A consultation on the second version of the Smart Metering Equipment Technical Specifications - Response from Energy UK

ZigBee Standards Development

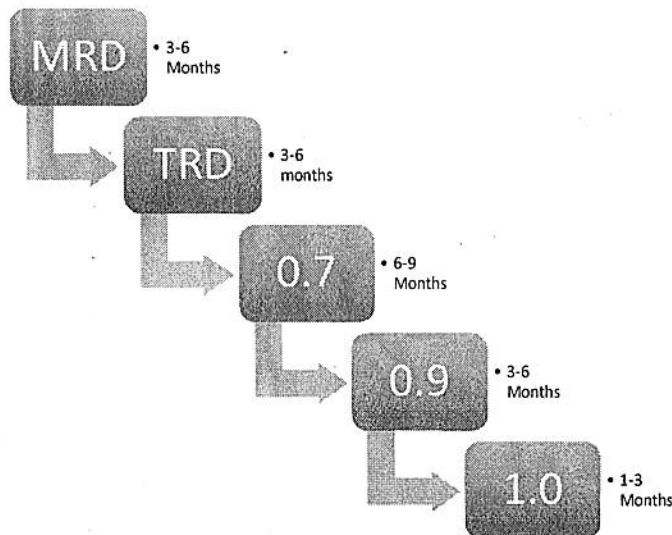
Yes, Energy UK supports additional measures to encourage the development of the 868 MHz solution or Sub GHz around 868MHz. Energy UK believe this is a critical path activity and DECC should be prioritising this work accordingly. We will continue to actively engage with stakeholders, including critically the Zigbee Alliance, to promote this solution.

Below is a draft timeline provided by the Zigbee Alliance which shows the timing implications of development of an 868 MHz solution:

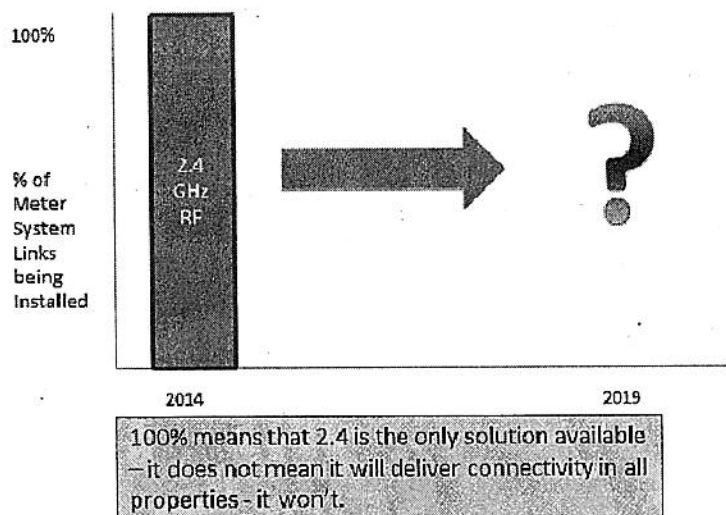
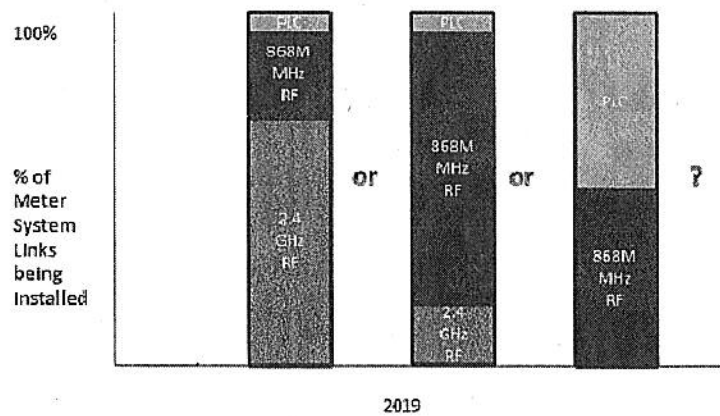
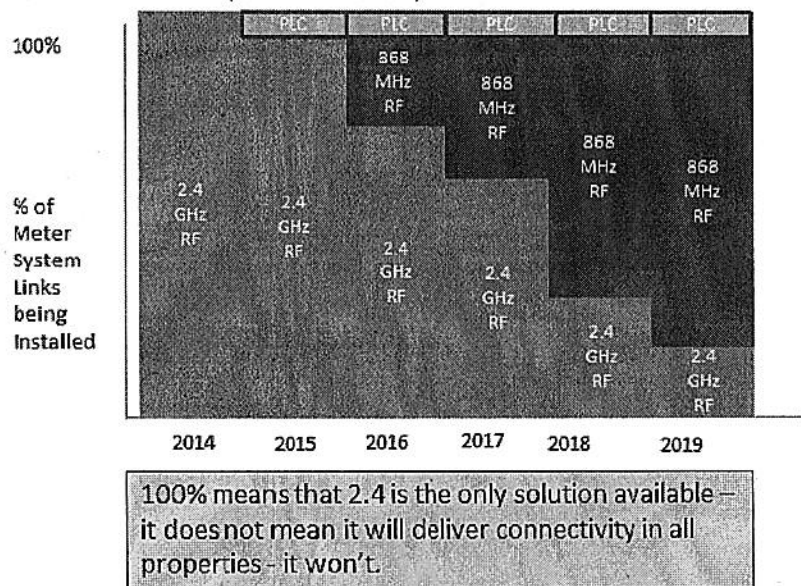
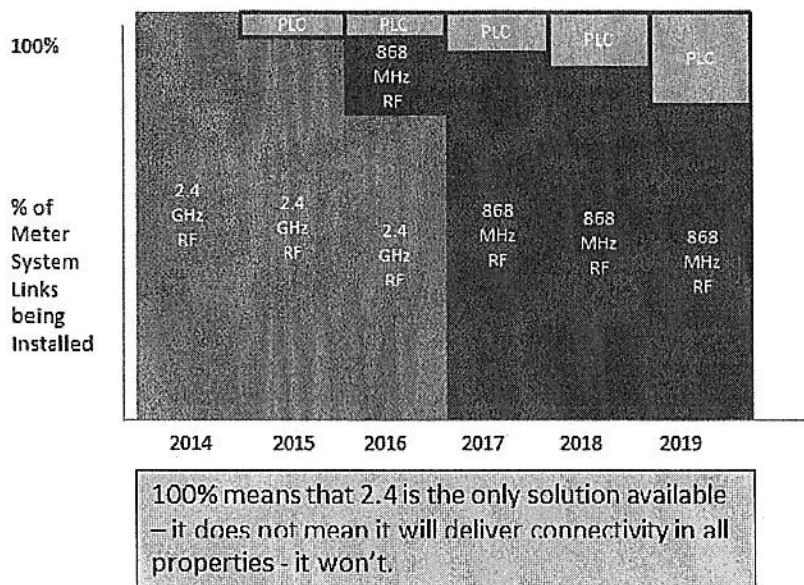
The following diagrams illustrate how little is known of the mix of HAN technologies that will be used for new installations as rollout progresses.

We have a known starting point in that 2.4GHz radio will be the first HAN technology available for SMETS compliant meters. When 2.4GHz is available, all the successful HAN links between devices will be 2.4GHz and where this does not work, there will be no complaint solution available, therefore the supplier has a choice of deploying non-compliant equipment that will subsequently need replacing or aborting the installation.

As more compliant HAN solutions become available, there will be more options available to suppliers for deployment, but we don't know if the later technologies (i.e. 868 MHz or PLC) will be used as infill when they are available or whether they will become preferred/default solutions.

In addition, we don't know the path that the technology mix being used for new installations will take. Will there be a gradual move to 868 MHz as it is first used to infill, then over time becoming the chosen solution (as shown below)?

Or will there be a rapid swap of technology with 868MHz being used as the primary HAN solution as soon as it is available?

Each diagram illustrates possible mix of HAN technologies being installed, not the mix of HAN technologies in the metering devices installed population.
